## STAFF RECOMMENDATION

1406 Fifth Avenue North

April 21, 2021

**Application:** Partial Demolition; New Construction—Addition and Outbuilding

Figure 2. the 1897 Sanborn Map shows a partial-width stoop

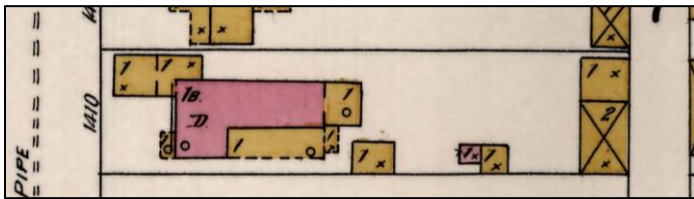
The 1897 Sanborn map depicts the house as having a small stoop or porch toward the right side of the front façade (Figure 2). However, the 1914 Sanborn map shows the house as having a full-width front porch (Figure 3). A photograph of the house from 1970 shows a full-width front porch; this is likely the same porch that appears on the 1914 Sanborn, although there may have been changes. This porch was removed sometime after 1970, and in 2008 a partial-width porch in the location of the one depicted on the 1897 map was constructed.

Figure 9. Contour elevations for the lot.

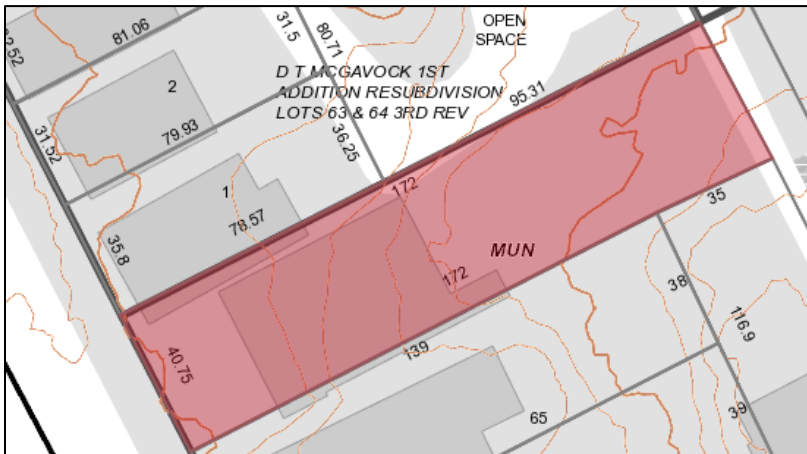
The proposed addition is located at the rear and is inset two feet (2') for the full depth on both sides, which is appropriate. The addition increases the footprint by approximately six hundred eighty-six square feet (686 sq. ft.) after the non-contributing additions are demolished; the footprint of the existing house is approximately one thousand, eight hundred, thirty-eight square feet (1838 sq. ft.).

Figure 10. The 1897 Sanborn map shows the brick portions as a pink and the frame construction as yellow. The rear and right/south facades were not 80% brick.

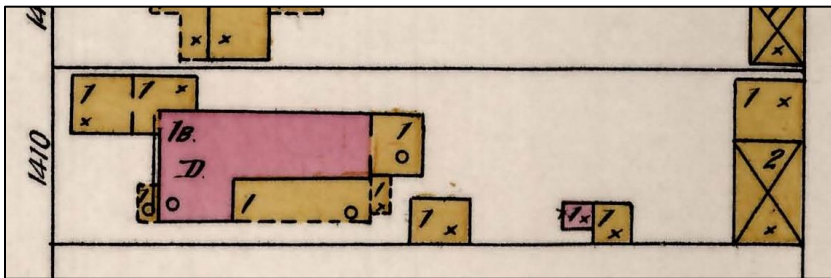
\*The design guidelines state that “All facades shall be at least 80% brick. A greater percentage of accent materials may be used on facades that are not visible from a public right-of-way.” The applicant proposes the addition to be clad entirely in siding. Staff finds that in this case, having an addition that contains no brick can be appropriate because historically, this historic house had substantial amounts of non-brick facades. Both the 1897 and the 1957 Sanborn maps show that the entire back of the house was frame and not brick and that about two thirds of the right/south façade was an enclosed wood porch (Figures 10 & 11). Parts of that wood porch section are now brick. Since historically, appendages and additions to this historic house were frame and not brick, staff finds that the proposed lap siding material to be appropriate for the addition.

Staff recommends approval of a brick sample as well as the trim, windows, doors, and porch posts prior to purchase and installation. With staff’s final approval of all material choices, staff finds that the known materials meet Sections III.E.5. and V. of the design guidelines.
